DATE: February 11, 2014
TO: Honorable Mayor and Members of the Village Council
FROM: John C. Gilbert, Village Manager
RE: Site Plan Review: 12-22-24 Crandon Boulevard and 51 Harbor Drive

DT: February 11, 2014
TO: John C. Gilbert, Village Manager
FR: Jud Kurlancheek, AICP, Director
Building, Zoning, and Planning Department
RE: Supplemental Site Plan Review Report and
Recommendation: 12-22-24 Crandon Boulevard and 51
Harbor Drive

DT: December 3, 2013
TO: John C. Gilbert, Village Manager
FR: Jud Kurlancheek, AICP, Director
Building, Zoning, and Planning Department
RE: Site Plan Review: 12-22-24 Crandon Boulevard
with access from 51 Harbor Drive

Intersection 2 Existing vs Safe Visibility

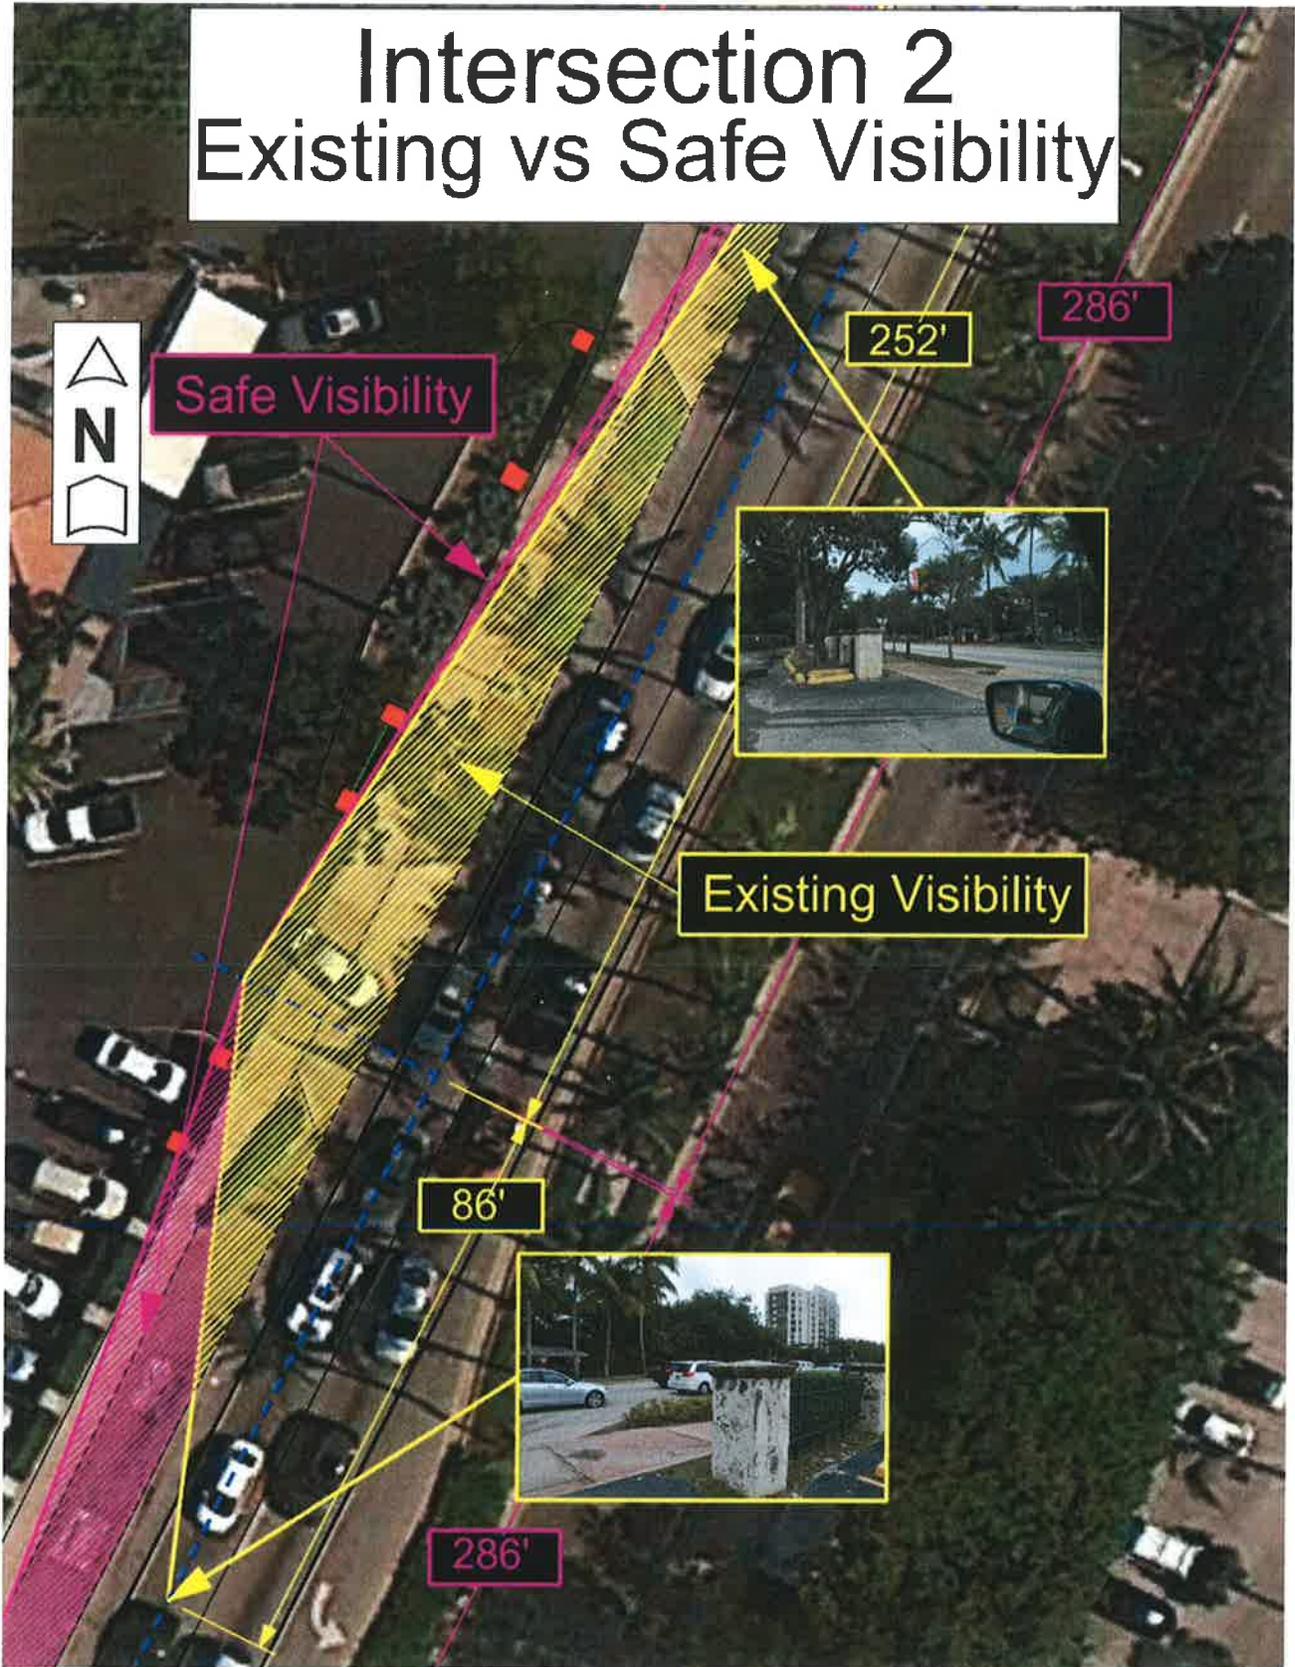
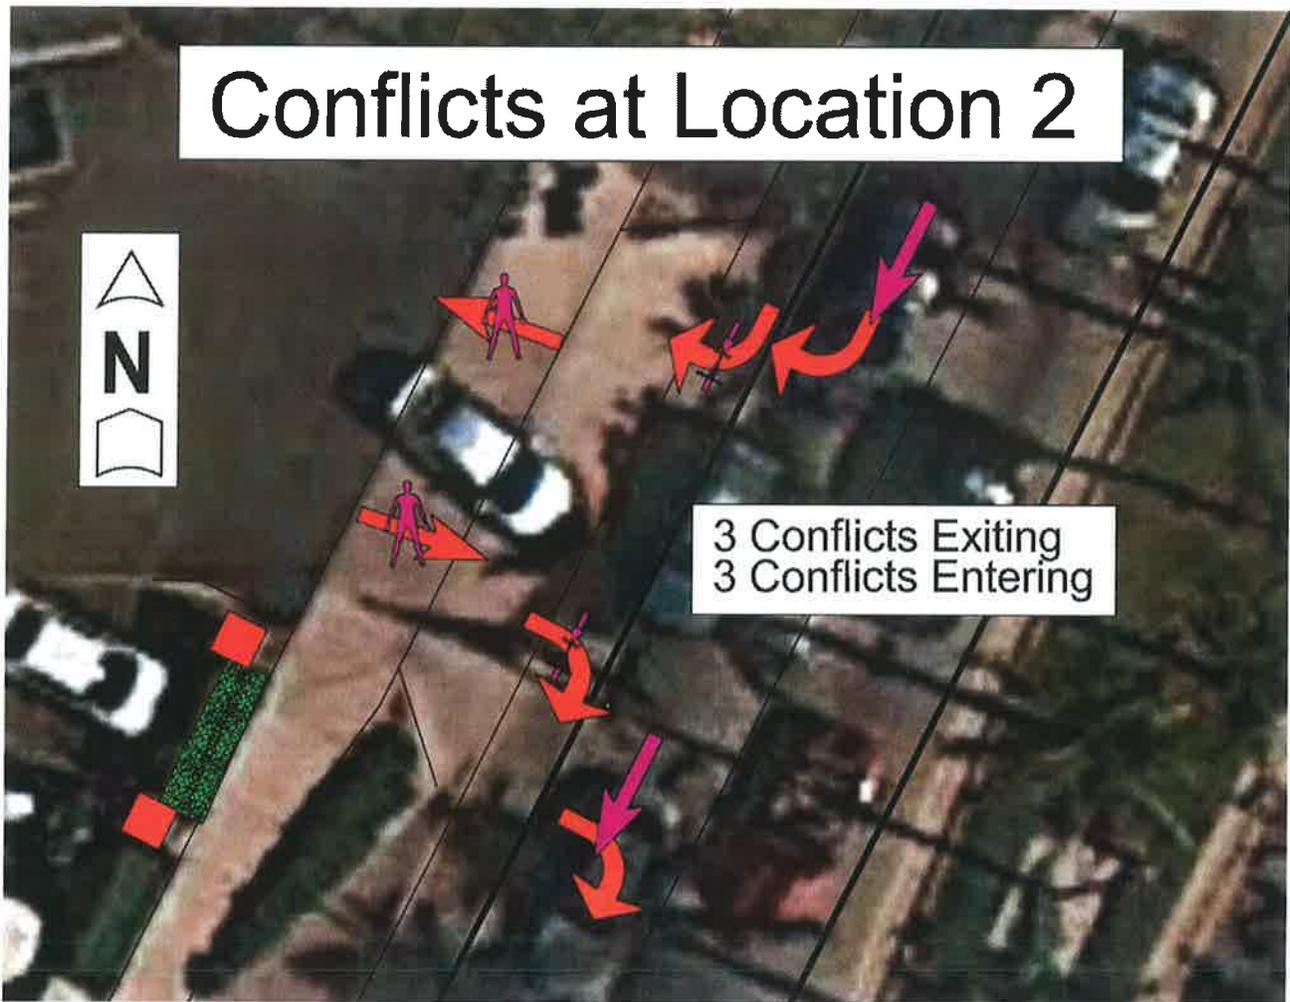
Exhibit 14 shows the visibility concerns with this location and **Exhibit 15** shows the various potential collisions at this location.

Exhibit 17

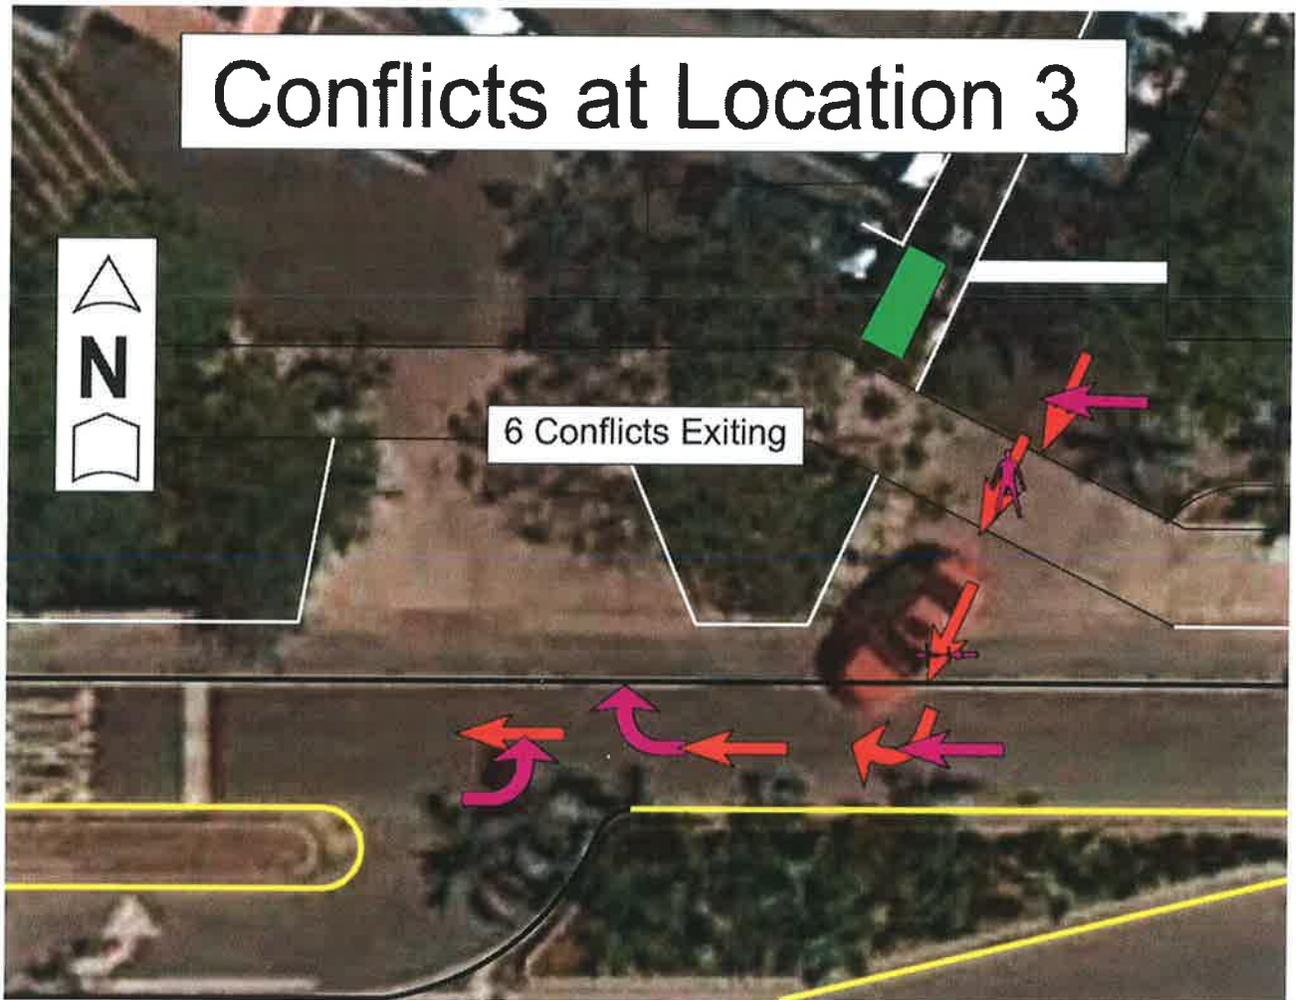
The second safety concern with this location is the number of potential collisions involving vehicles exiting the driveway. Vehicles exiting Oasis Café share the driveway with vehicles exiting via the cross-access ramp. Immediately after leaving the stop bar to exit onto Harbor drive there is a potential collision with vehicles exiting Oasis Café. Additionally vehicles exiting the driveway may collide with pedestrians when crossing the sidewalk, bicycles when crossing the bicycle lane, vehicles approaching or within the path of the lane being entered, vehicles slowing to turn right and vehicles turning left to enter the facility at the driveway immediately west of the exit. There are a total of six (6) potential collisions when exiting this driveway. **Exhibit 17** shows the various potential collisions at this location.

Exhibit 18

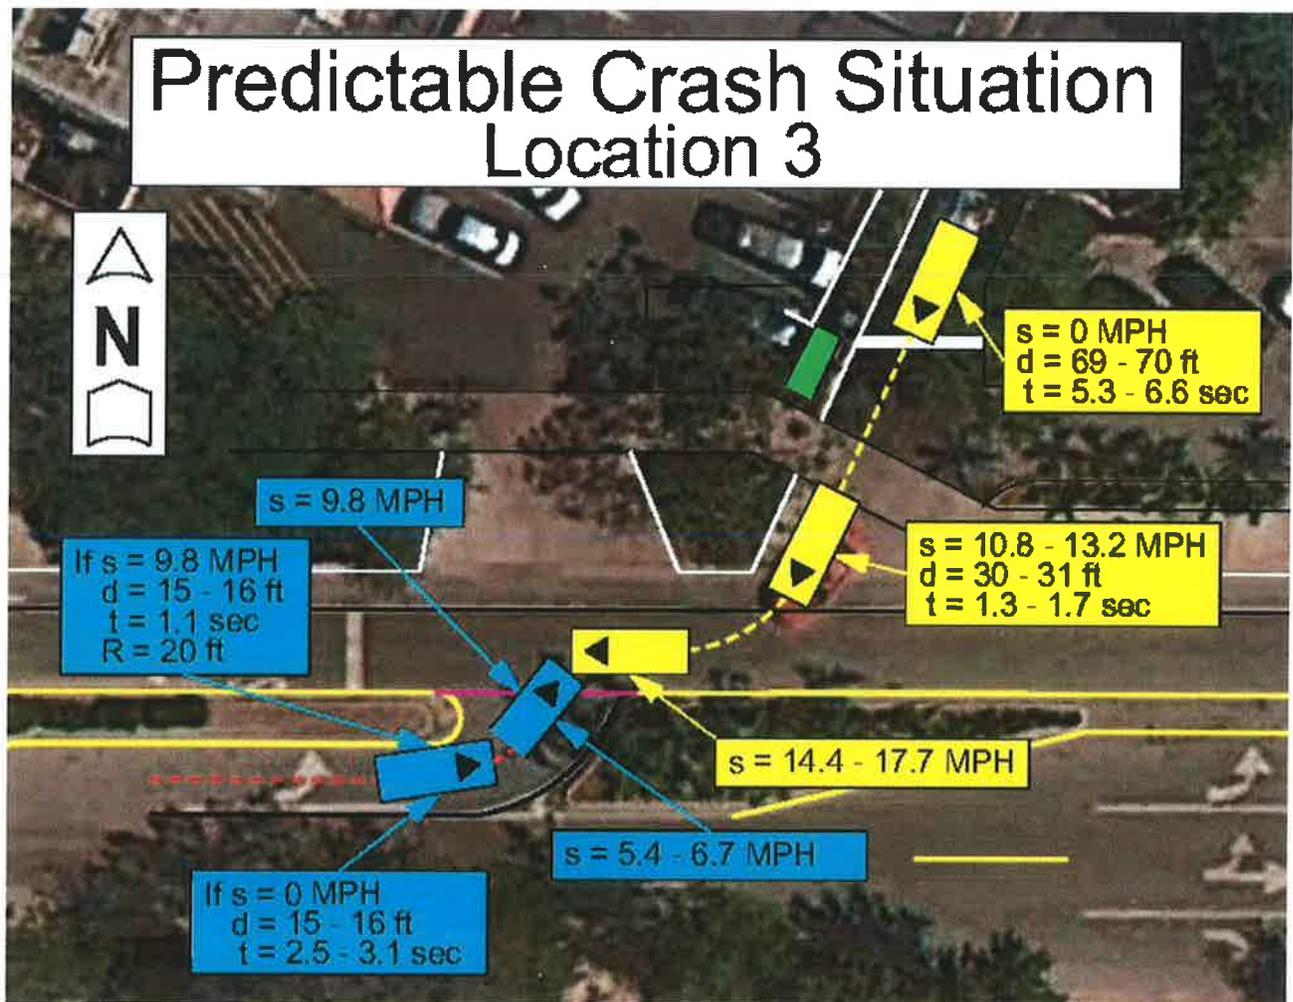
The third safety concern with this location is a predictable crash situation. Due to geometrics of this exit along with the eastbound left turn entrance into the facility, a collision between vehicles exiting and entering is possible where neither vehicle could have recognized the impending crash with enough notice to avoid a collision. A vehicle exiting the driveway from the stop bar would take about 5 – 7 seconds to reach the collision point. An eastbound entering vehicle stopped would take only about 2 – 3 second to reach impact, so it would still be stopped when the left turning vehicle begins its turn. The exiting vehicle would not enter Harbor Drive until it was 1 – 2 seconds from impact, meaning the entering vehicle would have already been accelerating for 1 – 2 seconds, therefore both vehicles are committed to their paths and neither has enough time to react and avoid the impact when the hazards are recognizable. If the left turning vehicle slowed to turn, but did not stop, then it would be less than 1 second from impact when it enters the roadway, and it would not have entered the turn bay when the exiting vehicle begins to accelerate. This would be an even less avoidable scenario. **Exhibit 18** shows the probable crash scenario at this location.

Conflicts at Location 4

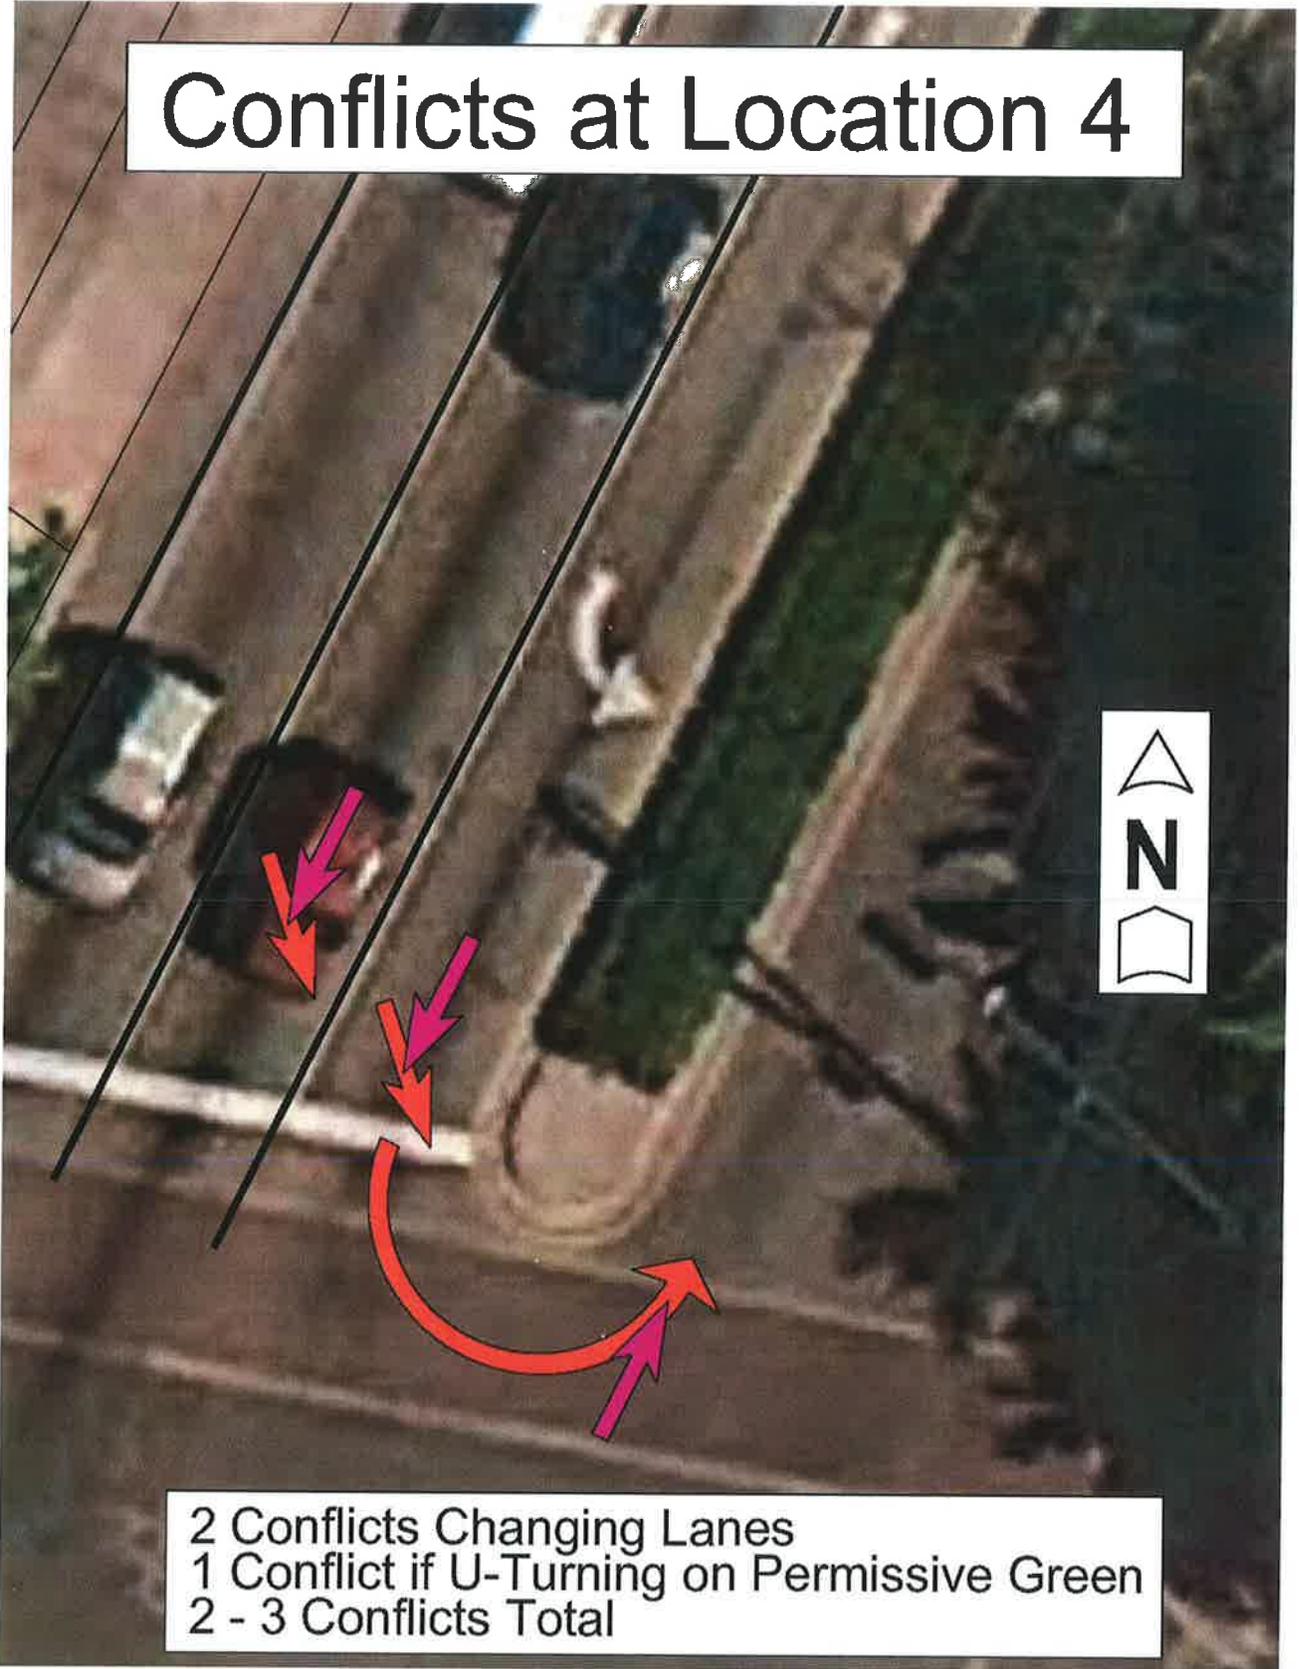
Location 4 is the U-turn that vehicles exiting the facility via Crandon Boulevard would be required to take in order to travel north. The traffic signal displays a green left turn arrow if vehicles arrive during a red signal, and also allows a left turn on a green “ball” signal. If arriving at other times, the main safety concern with this location is the number of potential collisions involving vehicles traveling this route. To reach the southbound left turn lane a vehicle must cross two lanes of traffic. At each lane crossing there is a potential collision with vehicles approaching the travel path or already within the travel path. In addition if making the maneuver on a green ball, there is a potential collision when completing the turn entering the northbound travel lane with approaching northbound vehicles. There are three (3) potential types of collisions at this location, in addition to the three potential collisions already experienced when exiting the facility onto Crandon Boulevard. **Exhibit 19** shows the various potential collisions at this location.

Exhibit 20

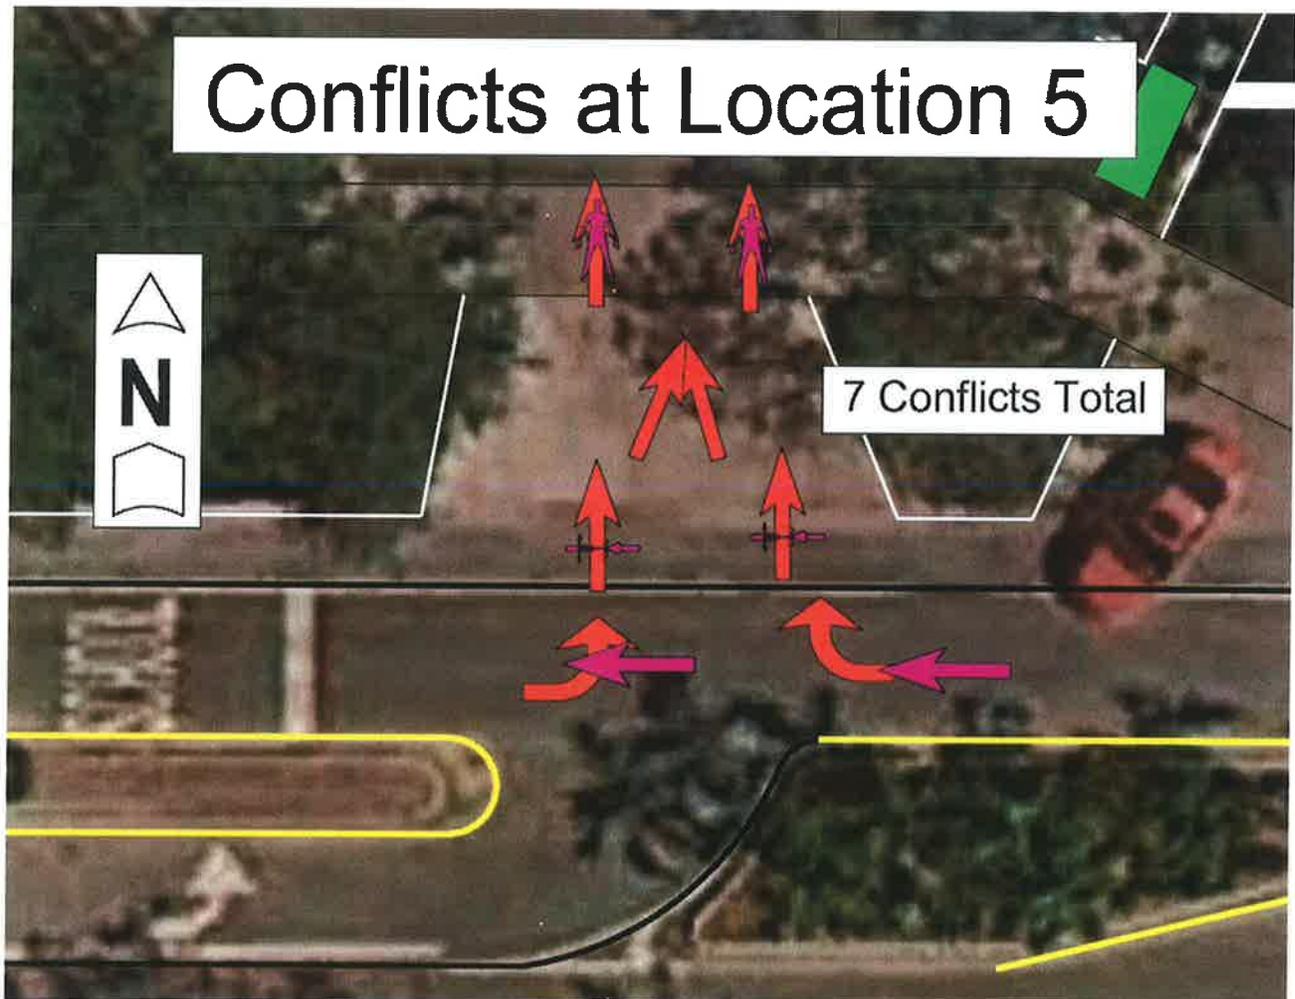
Location 5 is the entrance driveway from Harbor Drive that would access the proposed facility via the cross-access driveway. The main safety concern with this location is the number of potential collisions involving vehicles entering the driveway. Vehicles slowing to enter the driveway from westbound Harbor Drive, turning right, may lead to rear-end collisions, and in addition entering vehicles may collide with bicycles when crossing the bicycle lane and pedestrians when crossing the sidewalk. Vehicles entering the driveway from eastbound Harbor Drive, turning left may collide with vehicles traveling westbound on Harbor Drive, bicycles when crossing the bicycle lane and pedestrians when crossing the sidewalk. In addition vehicles entering from westbound Harbor Drive may collide with vehicles entering from eastbound Harbor Drive. There are a total of seven (7) potential types of collisions when exiting this driveway location. **Exhibit 20** shows the various potential collisions at this location.
